City of El Paso – City Plan Commission Staff Report

******REVISED******

Case No: SUSU15-00081 Sierra del Puerte Unit 4
Application Type: Resubdivision Combination
CPC Hearing Date: March 10, 2016
Staff Planner: Joaquin Rodriguez, (915) 212-1608
rodriguezjx3@elpasotexas.gov
Location: South of Hondo Pass and West of Dyer
Acreage: 16.182 acre
Rep District: 4
Existing Use: Vacant
Existing Zoning: PMD (Planned Mountain Development)
Proposed Zoning: PMD (Planned Mountain Development)
Nearest Park: Sunrise Park (.52 miles)
Nearest School: Park Elementary(.48 miles)
Park Fees Required: N/A
Impact Fee Area: N/A
Property Owner: GCGOHL, LLC
Applicant: GCGOHL, LLC
Representative: Roe Engineering

ATTACHMENT 3

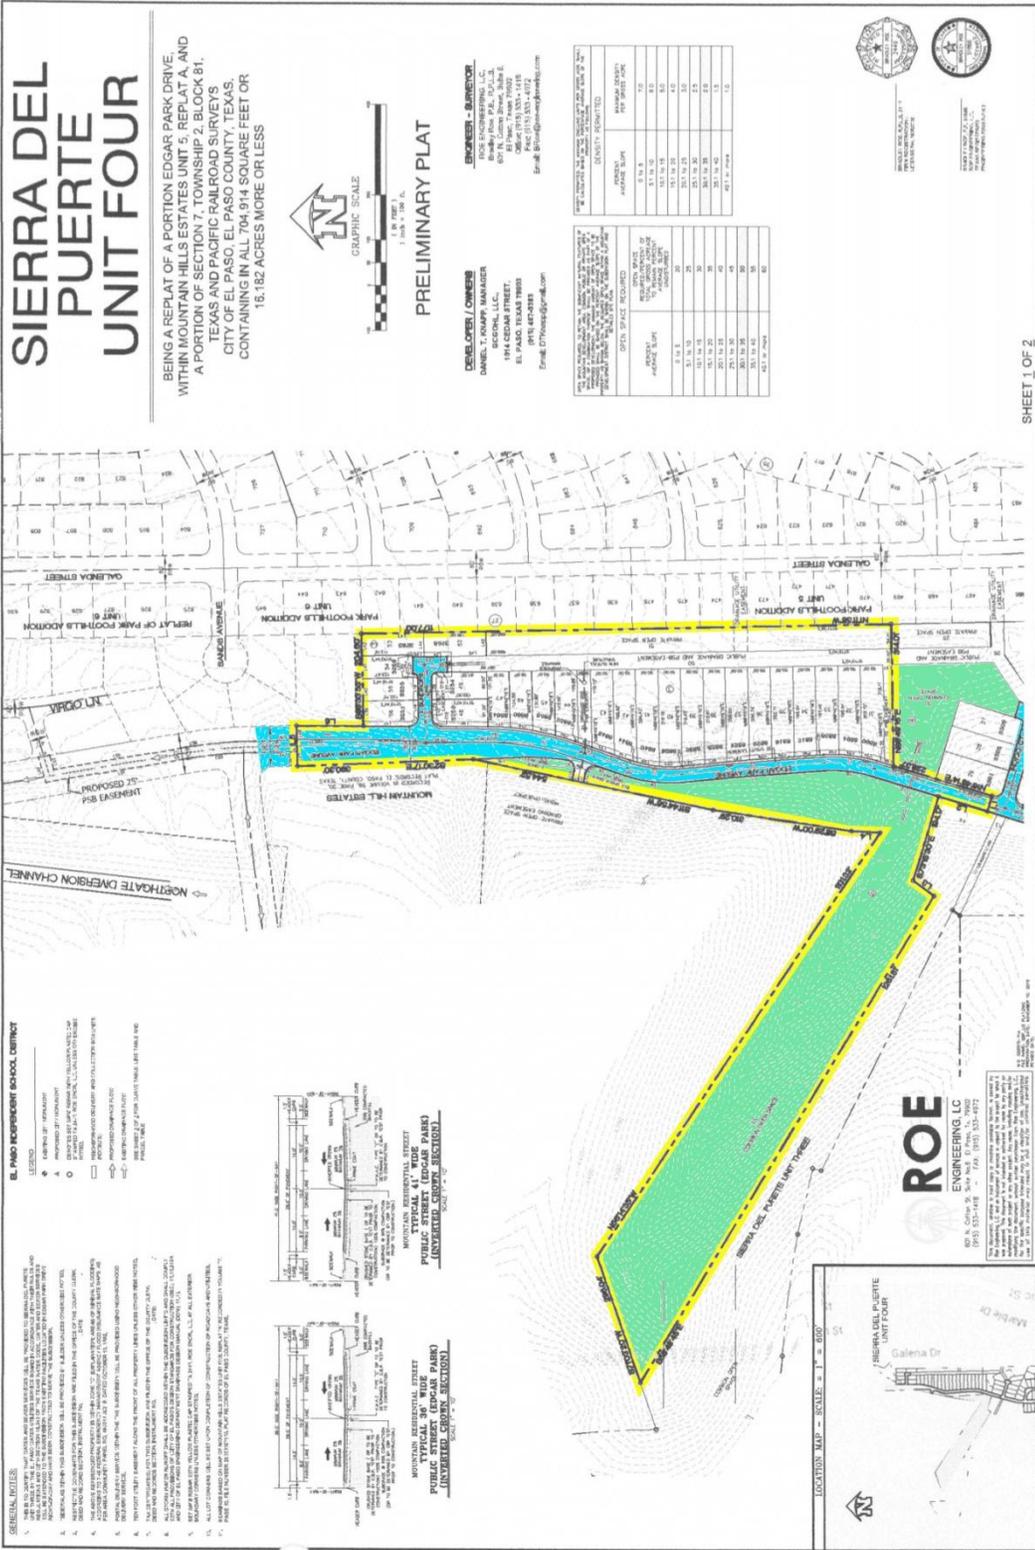
1. Comply with Section 19.24.030 - Development standards regarding re-vegetation of any disturbed common open space areas. Provide drainage and soils stability report at time of subdivision improvement plan review.
2. Delete note #8 on both plats, which states the need to retain developed stormwater runoff.
3. Provide response and approval letter from the Army Corps of Engineers for the 408 application submitted February 3, 2016, which applies to unit 3 which needs to be built

4. The maximum vertical height of a cut or fill shall be fifteen feet as per 19.24.030 - Development standards. Some of the areas covered by the proposed grading easements within the common open space areas contain grade differences of up to 35 feet vertically.

1. Water and Sanitary sewer main service to Sierra del Puerte Unit 4 is contingent upon the completion and final Acceptance of the water and sanitary sewer main extensions of Sierra Del Puerte Unit 3.
2. An Off-site water main extension to Virgo Lane is required within an easement following the alignment of Edgar Park and graded to future subgrade.

3. An 8-inch diameter water main extension will be needed along Edgar Park to the end of the subdivision. A loop water system extension will be necessary to provide service to Sundrops Ct. All costs associated with the extensions of water mains are the responsibility of the Owner/Developer.

4. An extension of an 8-inch diameter sanitary sewer line along Edgar Park and Sundrops Ct. is required to provide service to the subdivision. All costs associated with the extensions of sanitary sewer mains are the responsibility of the Owner/Developer.

The district recommends that the proposed street, Sundrops Ct be changed to something else. There currently exists a street named Sundrop Ct. Thank you.
